Management proxies for ccA

Current definition in IEC/IEEE 60802 Draft 3

6.4.5.5 Management proxies

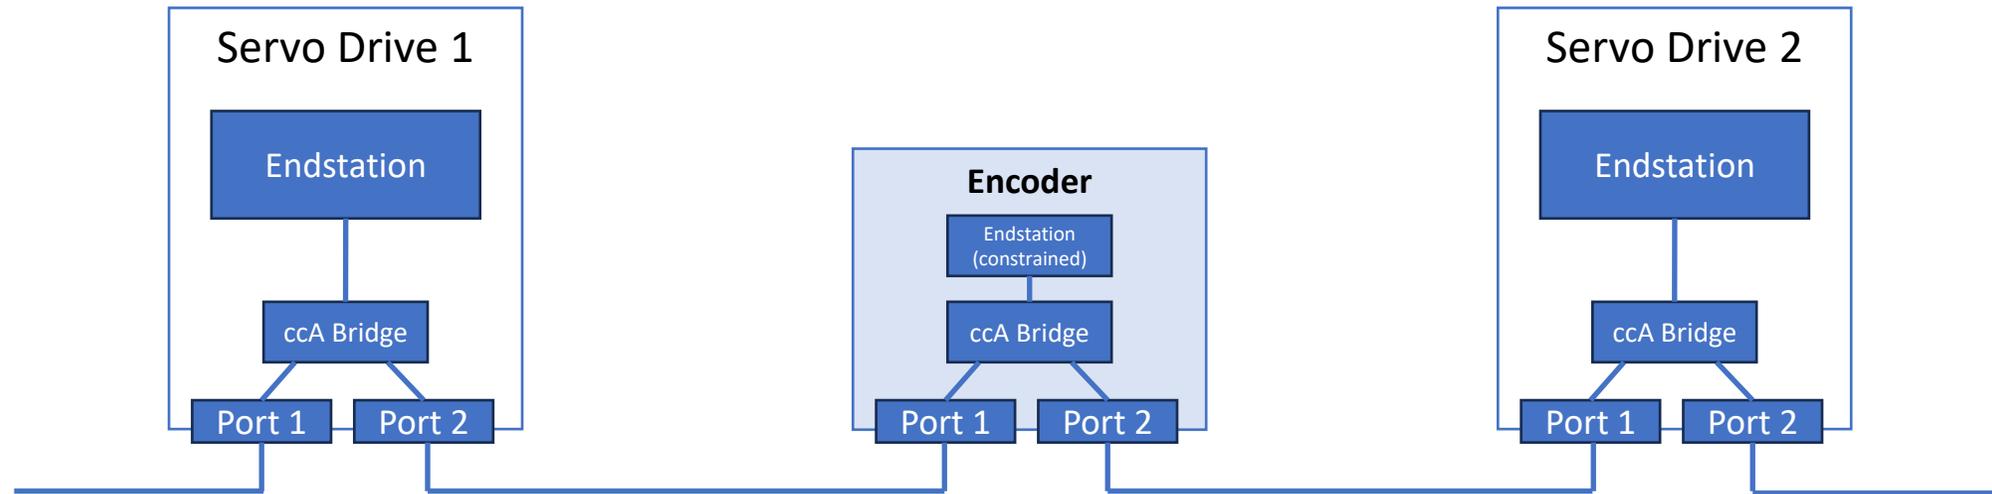
Problem: Sounds like ccA may not utilize Management proxies

Devices with ccA-Bridges might also benefit from the concept of Management proxies and should not be excluded by the specification.
